issue	description	date	verified
01	Issue for Review	20/7/21	01
02	Issue for Pre-DA	16/9/21	02
03	Issue for Pre-DA	27/9/21	03
04	Issue for DRAFT DA	8/10/21	04
A	Issue for Development Application	21/10/21	A
E	Issue for RFI Response	30/5/22	E

Dairy Farmers Corner

924 Hunter Street 2/DP445736
Newcastle West NSW 2302

Development Application

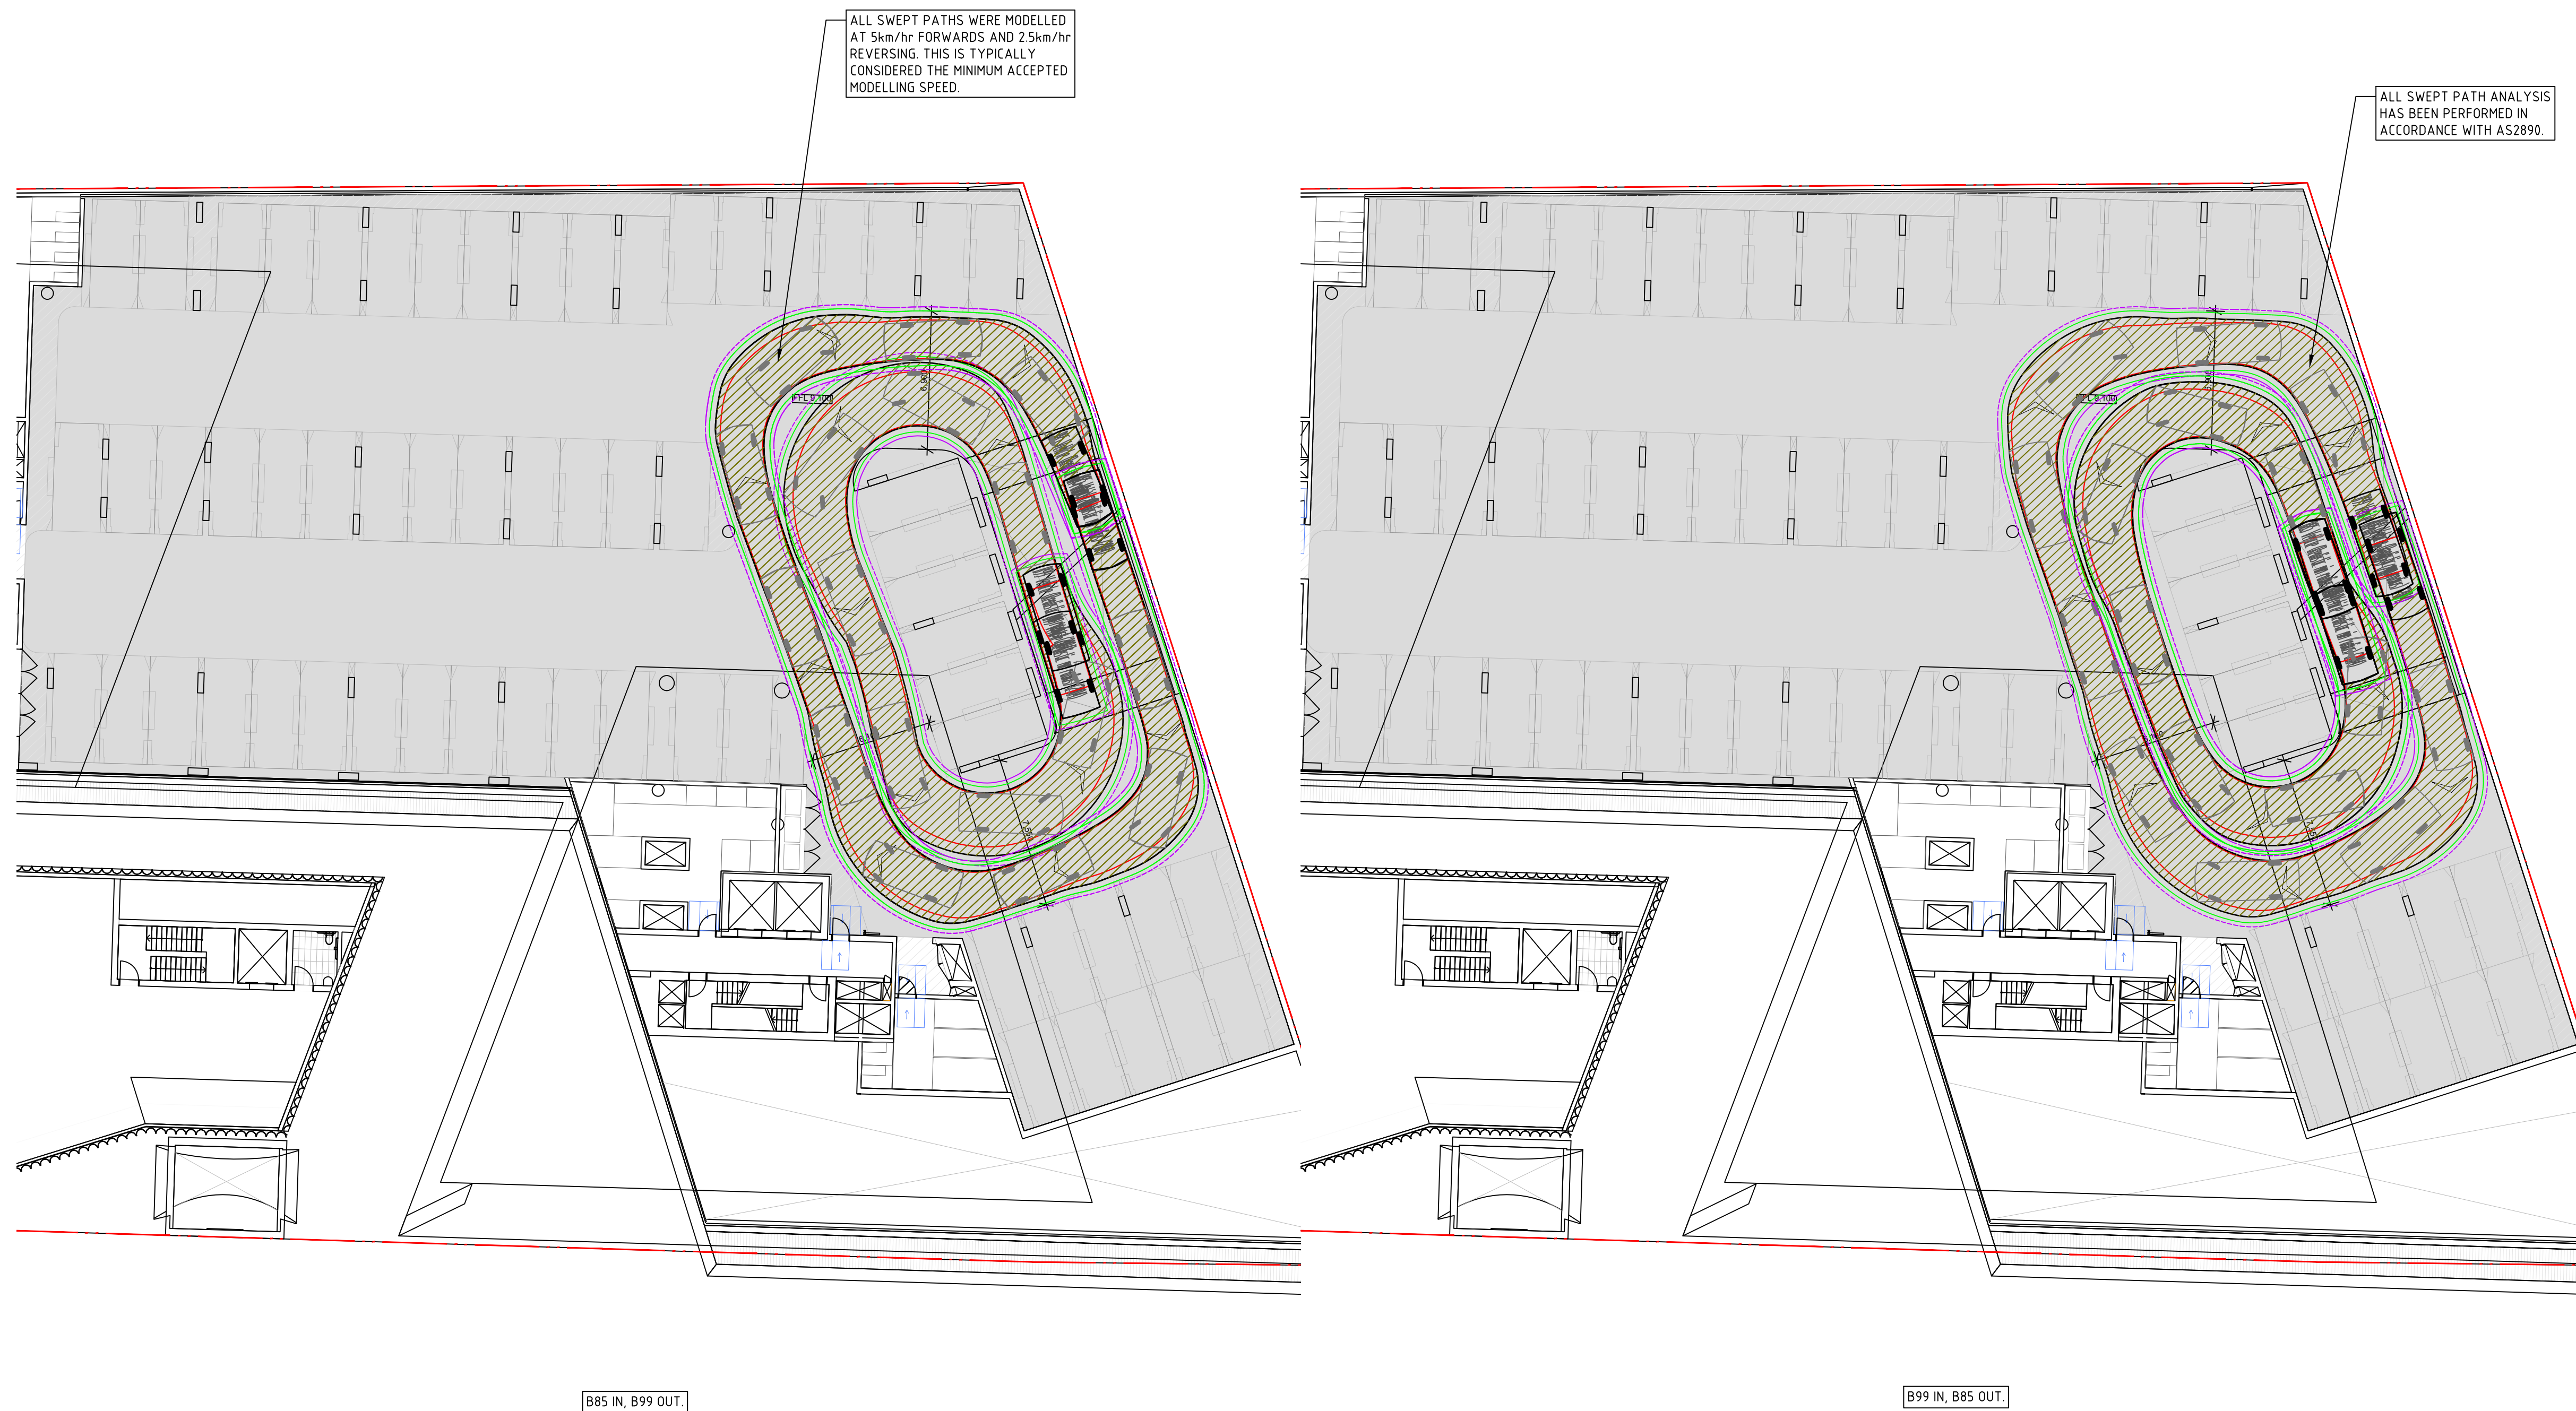
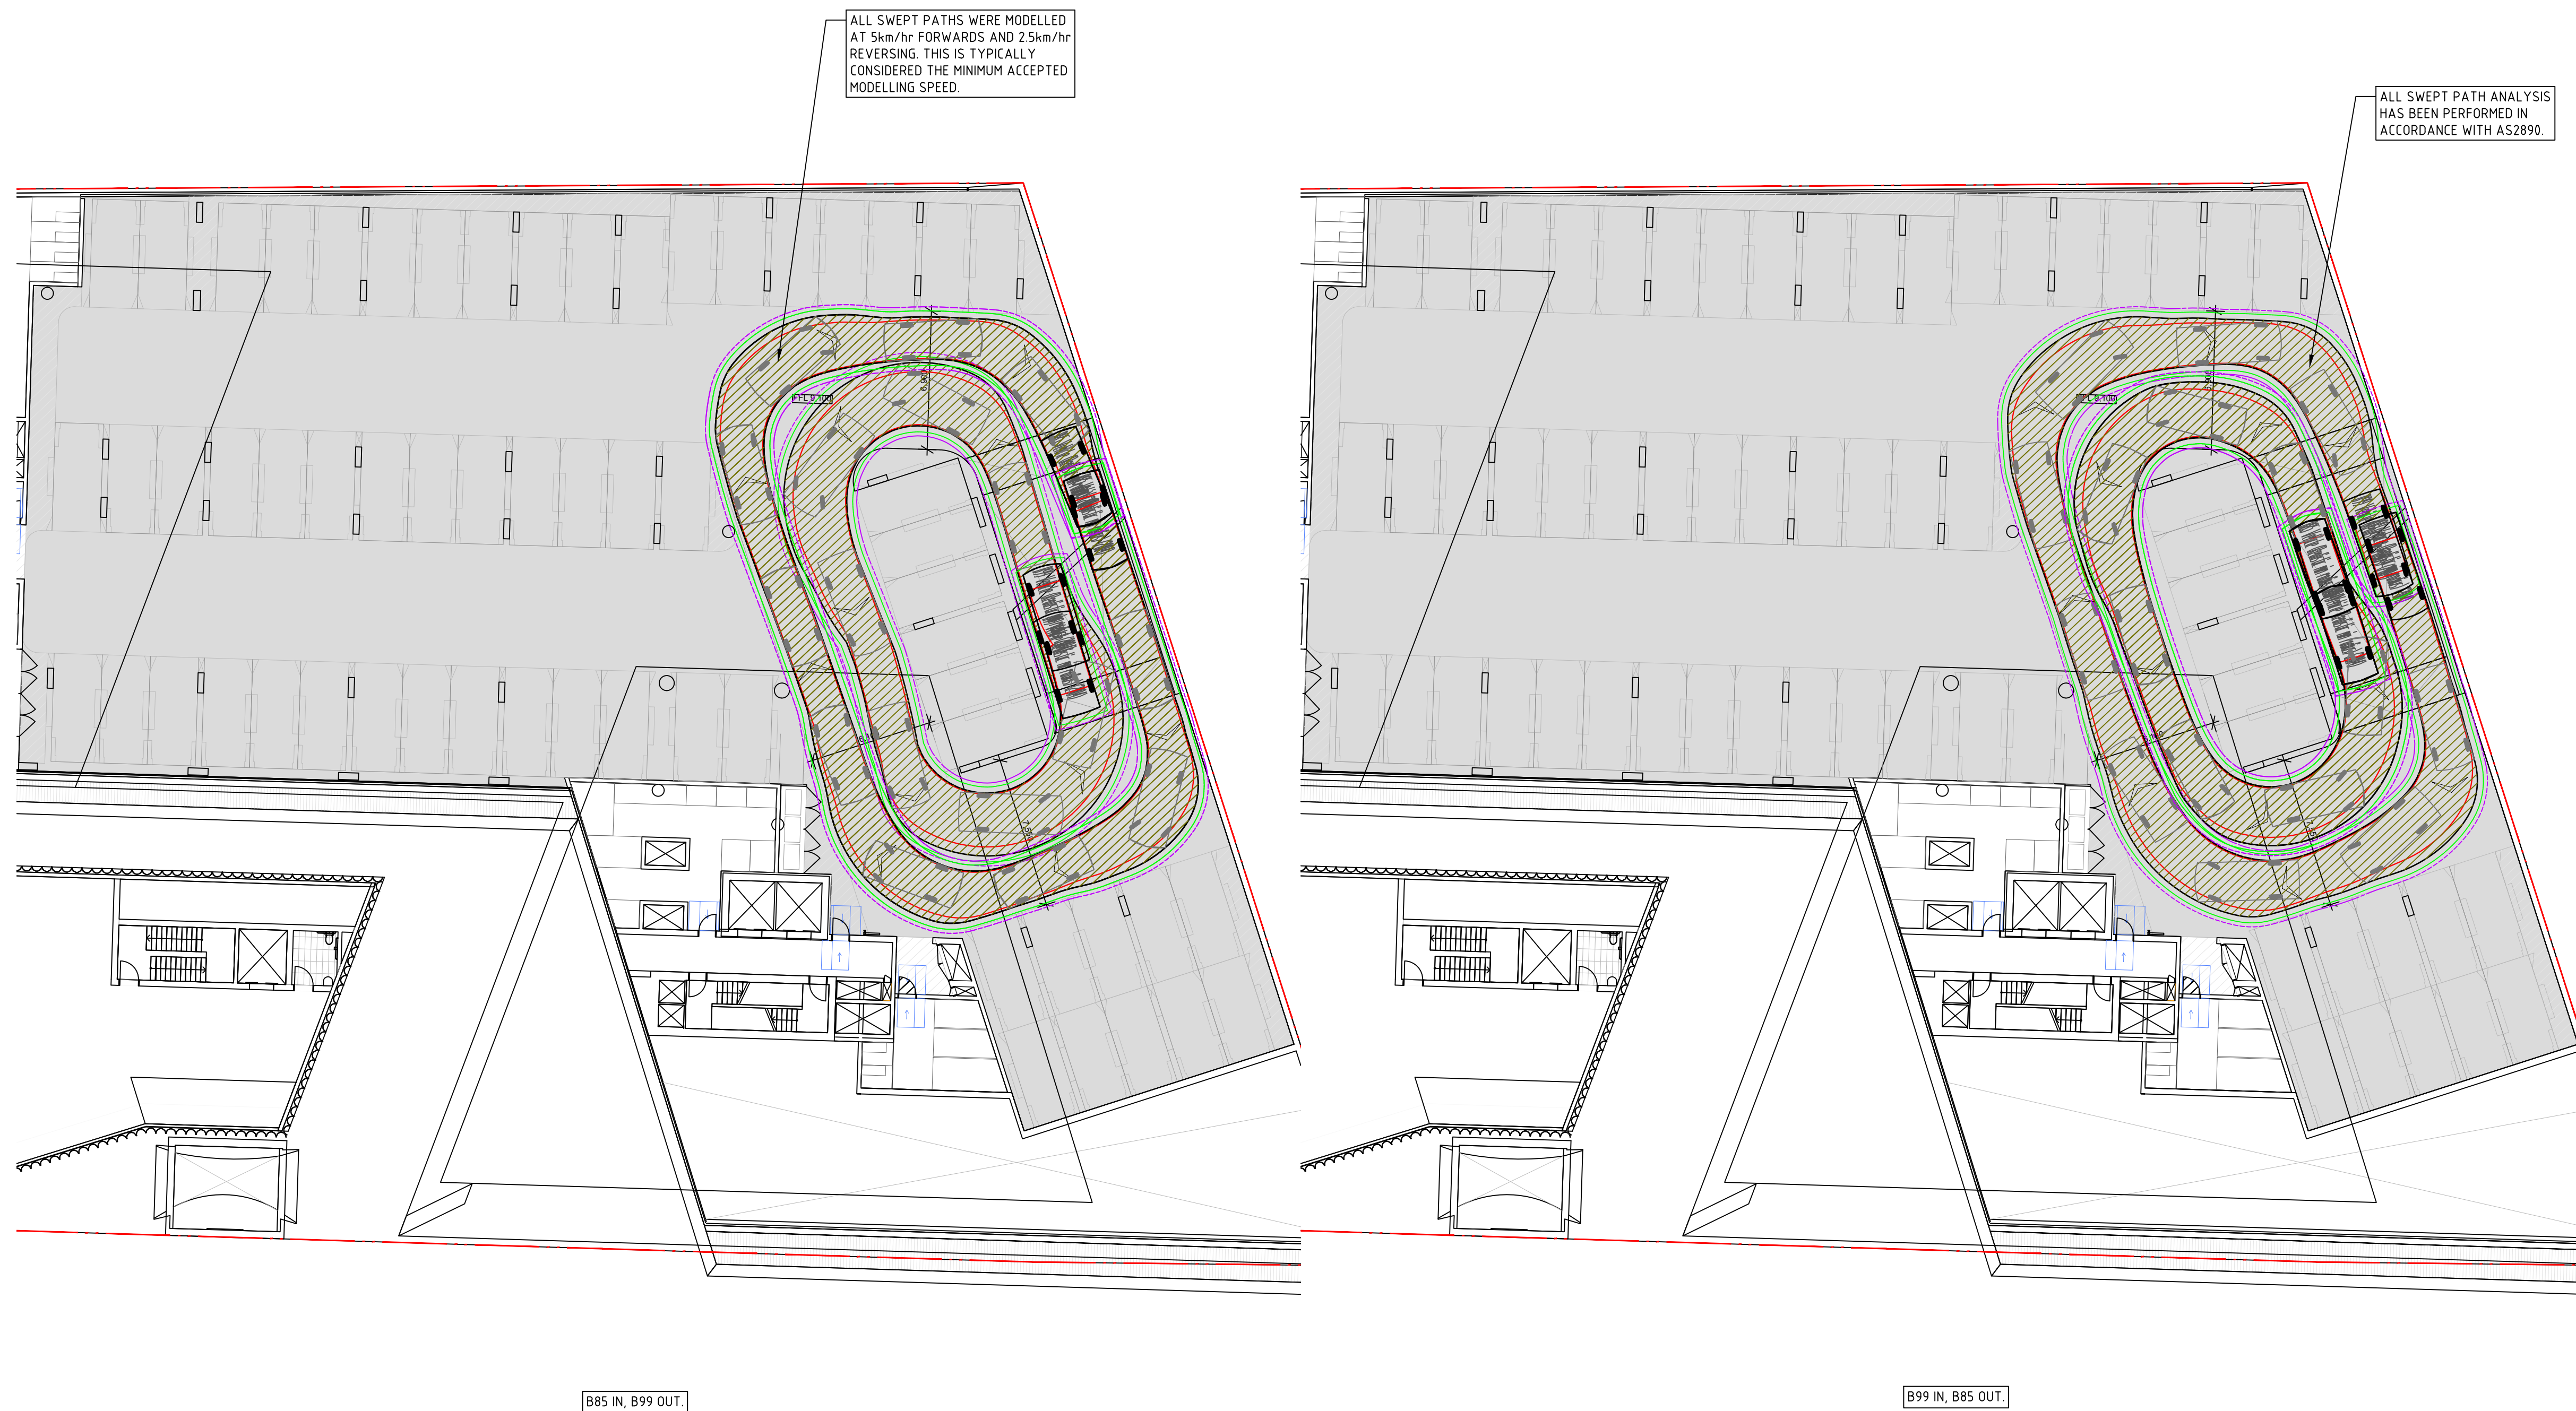
- b) *As was requested in the Pre-DA letter and the request for Further Information email sent 03 Feb 2022, swept path analysis is required demonstrating that Heavy Rigid Vehicle (HRV) movements associate with the intersection of Tighe St and Railway St and the proposed on-site Loading/Delivery Bay can be satisfactorily accommodated. The amended Civil Engineering Plan (Northrop DA-C06.01 Rev 2) only show swept path analysis for Medium Rigid Vehicles (MRV). Plans are again requested that show the swept path analysis for HRV for the movements previously assessed for MRV. For clarity, such plans are also to show the relevant existing lane and centreline road markings on Hunter St and Railway St and any proposed adjustments to these lane configurations and/or signal detector loops associated with the traffic control signals.*

As was requested in the Pre-DA letter and the Request for Further Information email sent 03 Feb 2022, swept path analysis is required demonstrating that Heavy Rigid Vehicle (HRV) movements associate with the intersection of Tighe St and Railway St and the proposed on-site Loading/Delivery Bay can be satisfactorily accommodated. The amended Civil Engineering Plan (Northrop DA-C06.01 Rev 2) only show swept path analysis for Medium Rigid Vehicles (MRV). Plans are again requested that show the swept path analysis for HRV for the movements previously assessed for MRV. For clarity, such plans are also to show the relevant existing lane and centreline road markings on Hunter St and Railway St and any proposed adjustments to these lane configurations and/or signal detector loops associated with the traffic control signals.

The additional assessment has been undertaken and is included in drawing C06.06. As shown, an HRV is not able to access Tighe St, and it is therefore proposed to limit access to the development to MRV only, as originally nominated. Please refer to traffic engineer responses for further clarification.
